Assessment of the Volume Adequacy of Secondary Containment Structures of the Piñon Ridge Mill License Application

October 11, 2010

Energy Fuels Resources Corp. reviewed the CH2MHILL preliminary drawings for adequacy of volumetric containment meeting or exceeding 110% of the largest process tank within the containment area.

Containment Area 400-S-001-2
 Solvent Extraction Building - Uranium SX Feed Tank Area
 Largest Tank: (31) Uranium SX Feed Tank, 420-TKH-01
 Vol = 10,619 cu.ft.
 Vol at 110% = 11,680 cu.ft.

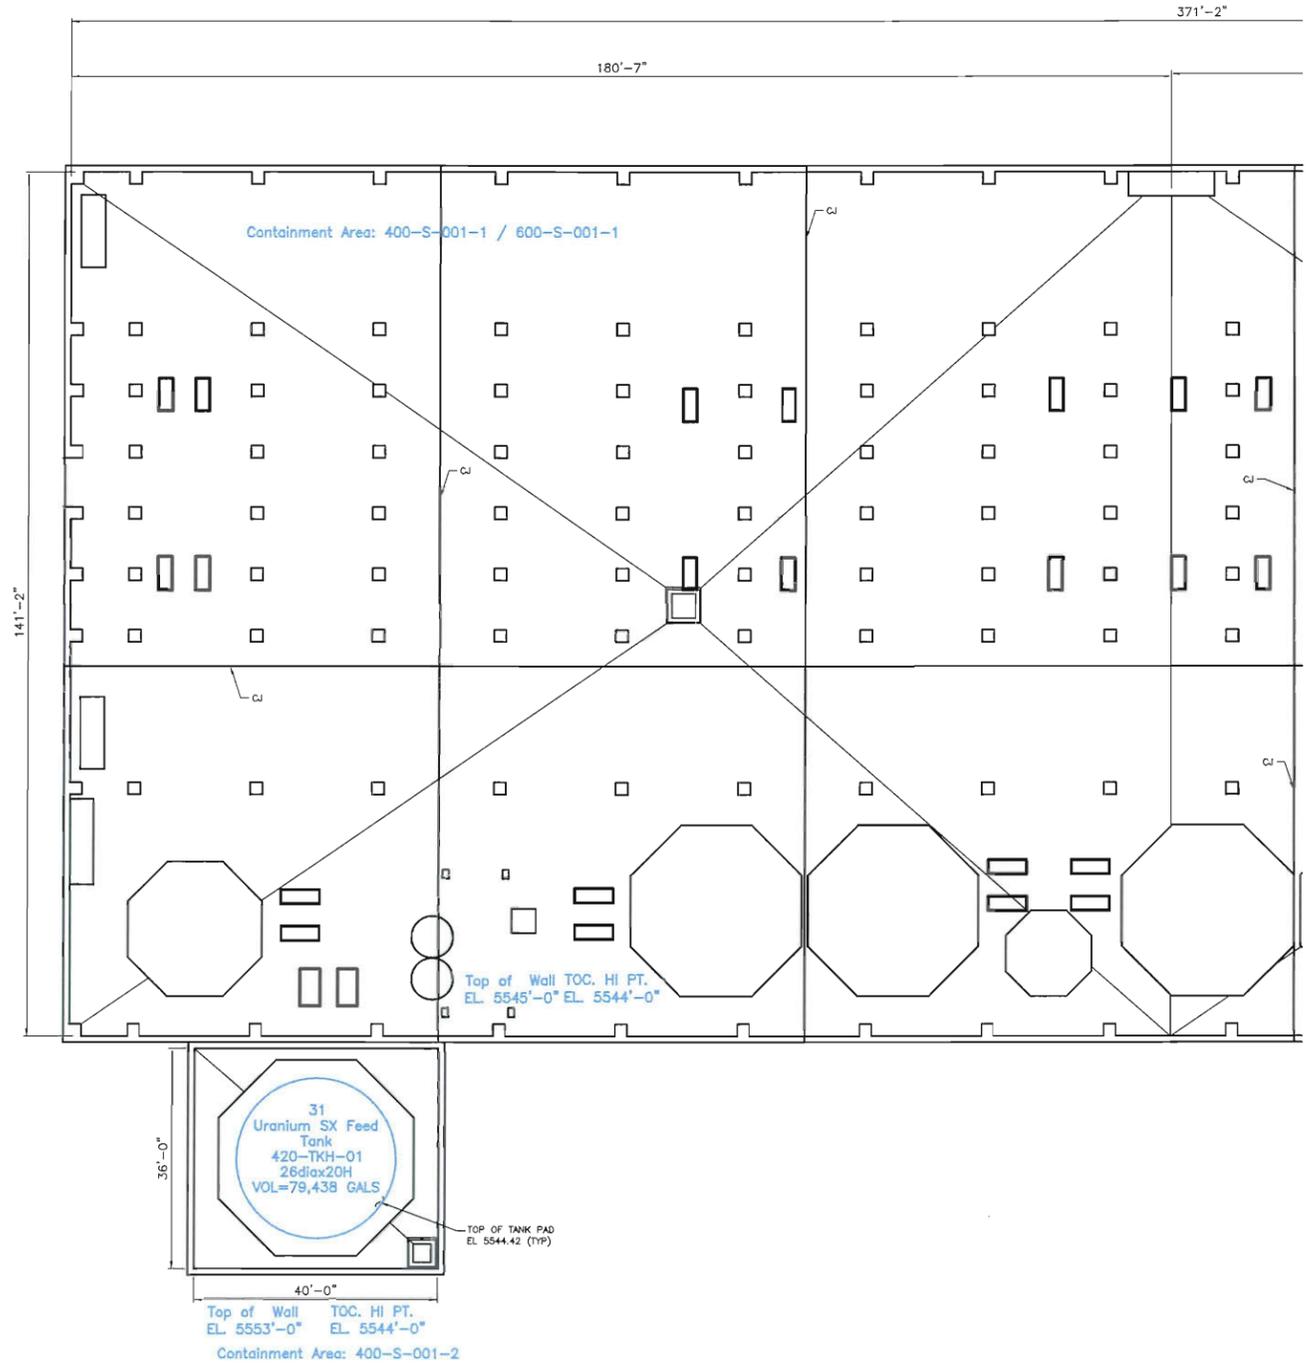
Containment: Outside, Rainfall - 4.43" (1000 yr, 24 event)
 Area: 36' x 40' = 1,440.0 sq.ft.
 less wall fdn's (0)x0sq.ft. = 0.0 sq.ft.
 Containment Area = 1,440.0 sq.ft.
 Wall Ht. (5553.0-5544.0) = 9.0 ft.
 Containment Volume = 12,960.0 cu.ft.
 + 1 Sump Volume (3x3x3) = 27.0 cu.ft.
 Total Containment Volume = 12,987.0 cu.ft.

- rainfall at 4.43" = 531.6 cu.ft.
 - 1 sump pump = 8.0 cu.ft.
 - 1 Tank Base (848.3 sq.ft.x0.5') = 424.2 cu.ft. Note 2
 - 1 Tank (530.9sq.ft.x0.0') = 0.0 cu.ft. Note 1
 Avail Containment Volume = 12,023.2 cu.ft.

Avail Containment = 12,023.2 cu.ft.
 Largest Tank (at 110%) = 11,680.0 cu.ft.
 Difference = 343.2 cu.ft.
 Containment Overage factor = 1.03
 Avail Containment Vol., % of Largest Tank Vol. = 113.2%

Note 1 - The largest tank volume is not a deduction
 Note 2 - Dwg 400-S-001 Shows the tank pad at 0.42' (5").
 Conservatively, this calculation used 0.5' (6")
